Access Compliance Report

Public Rights-of-Way

(Curb Ramps)

Intersection ID: 2857	Main Street: BEAUVISTA_DR	Cross Street: BEECH_COVE_LN	Location: NW
ADA ID: 3763B957DF79	Ramp Type: PerpDiag	Initial Pass/Fail: Fail	Overall Compliance: No
Severity Score: 33.75			
Codes/Mitigation Info/Possible Solution		Field Measurements/Component Compliance

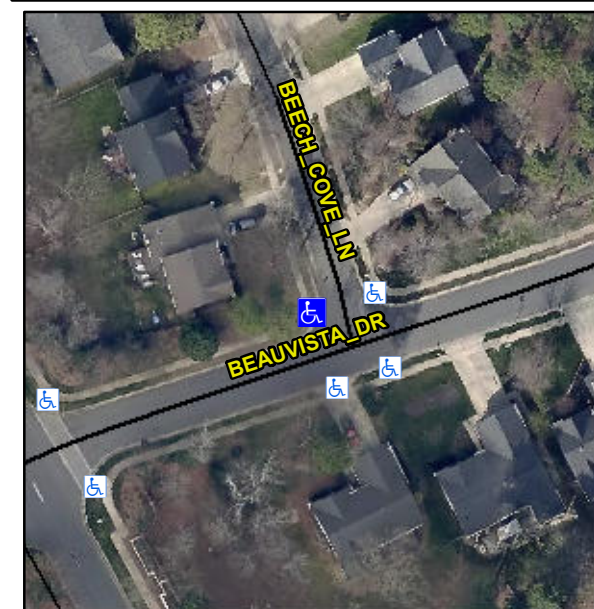
Not Found, R304.5.1, R304.2.2, R304.5.3

Compliance	Description	Data	Compliance	Description	Data
N/A	Ramp Length (in)	43.0	No	Ramp Slope (%)	10.2
No	Ramp Width (in)	37.5	No	Ramp XSlope (%)	6.8
N/A	Flare Type LT	N/A	N/A	Flare Type RT	N/A
N/A	Flare Slope LT (%)	N/A	N/A	Flare Slope RT (%)	N/A
N/A	Flare Traversable LT?	N/A	N/A	Flare Traversable RT?	N/A
N/A	Landing Length (in)	N/A	N/A	DWS Provided?	N/A
N/A	Landing Width (in)	N/A	N/A	DWS Contrast?	N/A
N/A	Landing Slope (%)	N/A	N/A	DWS Length (in)	N/A
N/A	Landing X Slope (%)	N/A	N/A	DWS Full Width?	N/A
N/A	Landing Curb? (Y/N)	N/A	N/A	DWS Offset (in)	N/A
N/A	Shared Landing?	N/A			
N/A	Gutter Ponding?	N/A	N/A	Gutter Slope (%)	N/A
N/A	Gutter Lip Ht (in)	N/A	N/A	Gutter X Slope (%)	N/A
N/A	Painted X Walk1?	No	N/A	Painted X Walk2?	No
	X Walk 1 Direction	To S		X Walk 2 Direction	To E
N/A	X Walk 1 Width (in)	N/A	N/A	X Walk 2 Width (in)	N/A
	X Walk 1 Slope (%)	6.1		X Walk 2 Slope (%)	6.4
	X Walk 1 X Slope (%)	7.0		X Walk 2 X Slope (%)	0.9

N/A	Ramp inside XWalk1?	N/A	N/A	Ramp inside XWalk2?	N/A
	Road Slope (%)	4.0	N/A	Clear Space?	N/A
	Road X Slope (%)	8.7	N/A	Clear Space to XWalk (in)	N/A
N/A	Any Obstructions?	N/A	N/A	Storm Grate/Utility Hazard?	N/A
	Obstruction Type			Storm Grate/Utility Type	
		N/A			N/A
			Yes	Surface Condition? (G/P)	Good

Remove & Replace Curb Ramp With Two New Directional Ramps or Equivalent.
